APPENDIX A: INSTRUMENT OF REFUSAL

Concept Plan Refusal

MP 06_0153

Review of Environmental Assessment for Lot 156 Creek Street, Hastings Point

Mapped SEPP 14 wetland and actual wetland boundaries

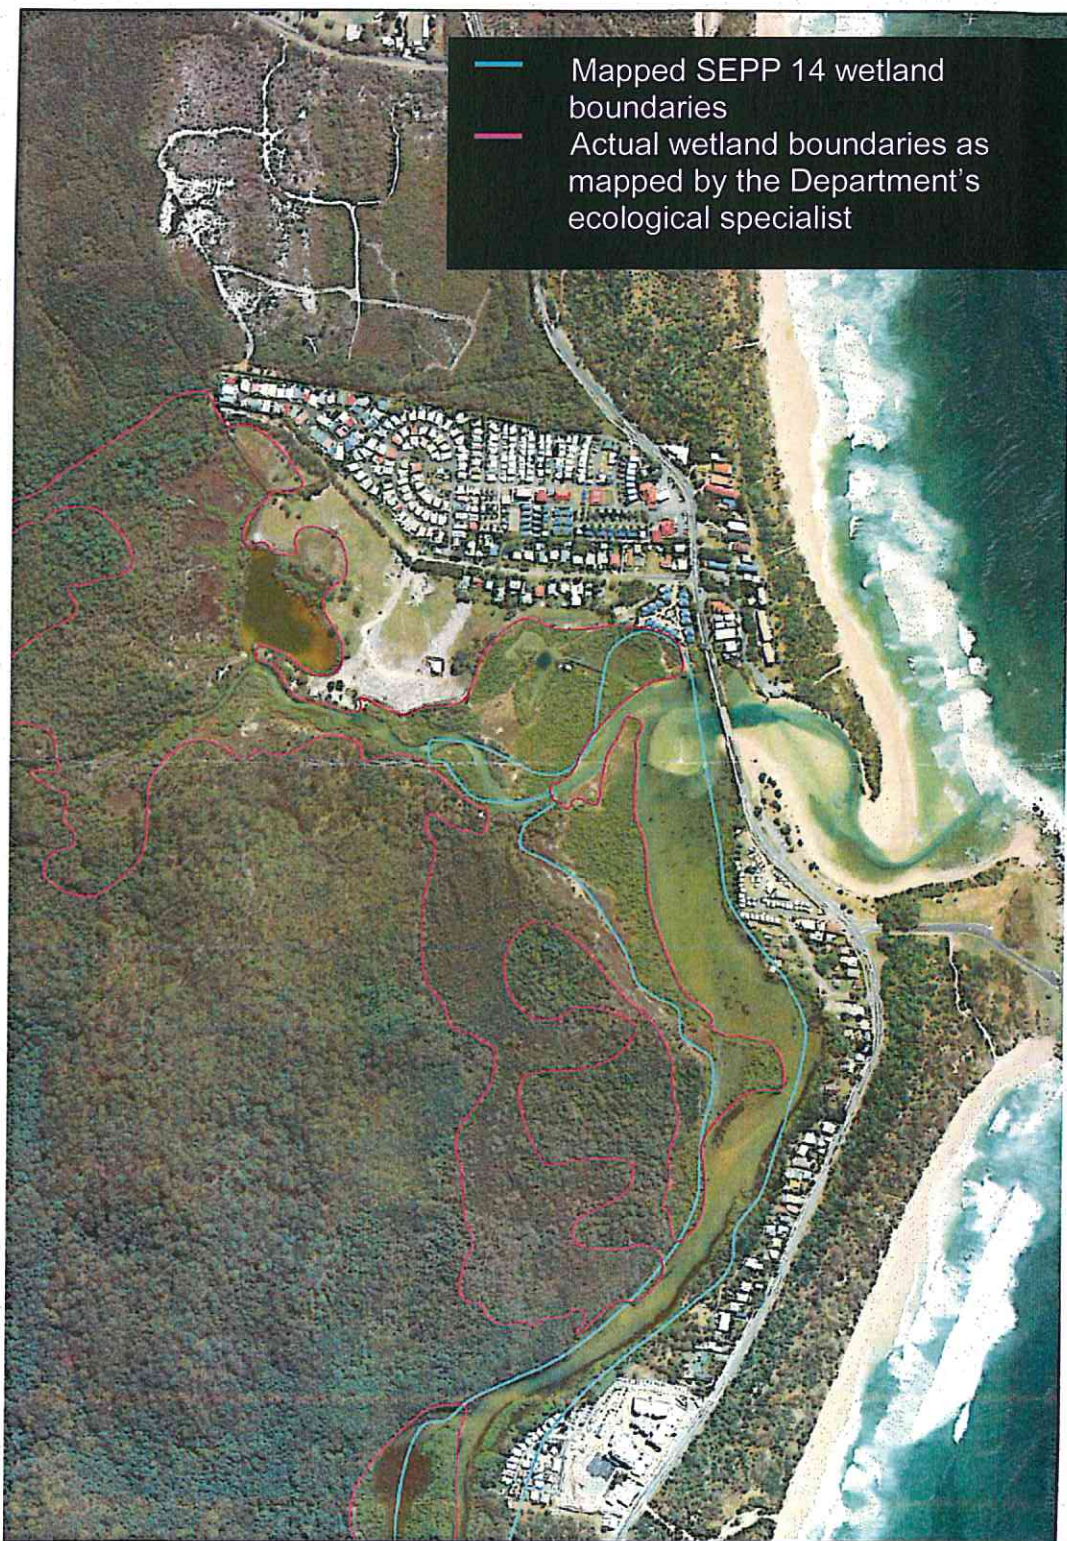
State Environmental Planning Policy No 14 – Coastal Wetlands ("SEPP 14") aims to ensure that identified coastal wetlands are preserved and protected in the environmental and economic interests of the State. A SEPP14 Coastal wetland is mapped to be 20m from the site (**Refer to figure below**). The Department's ecological specialist surveyed the site and mapped the actual wetland present in the area. The development has an unacceptable risk of adversely impacting the SEPP 14 wetland as discussed within section 5 of this report.
